ON-SITE SEWAGE DISPOSAL SYSTEM HOWARD COUNTY HEALTH DEPARTMENT BUREAU OF ENVIRONMENTAL HEALTH

SUBDIVISION: Wellington West LOT NUMBER: 29

ADDRESS: 15320 Doe Hill Court PROPERTY OWNER: Pulte Home Corp.

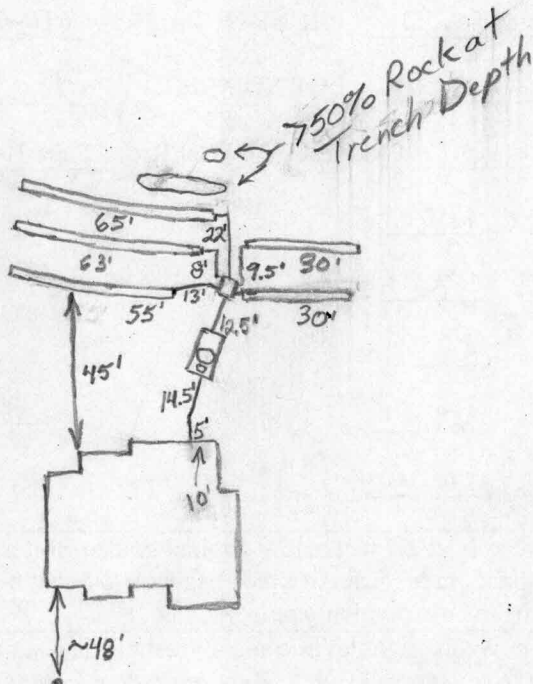
PRE-CONSTRUCTION INSPECTION: 7/12/01 Contour different than on plans To install a

short 45'-50' trench which may be deeper than 4' on highest part of easement. To

INSPECTION COMMENTS: install 3 more trenches ~65' and work with contours and

spacing as best possible. (BB) 7/12/01 Encountered excessive rock while

digging last trench. To install two short trenches to the right of

distribution box out of easement area to compensate. No house

connection. (BB) 7/13/01 The 2-30' trenches are done. Still need house

connection. (BB) 9/12/01 Plumber putting in house connection. (BB)
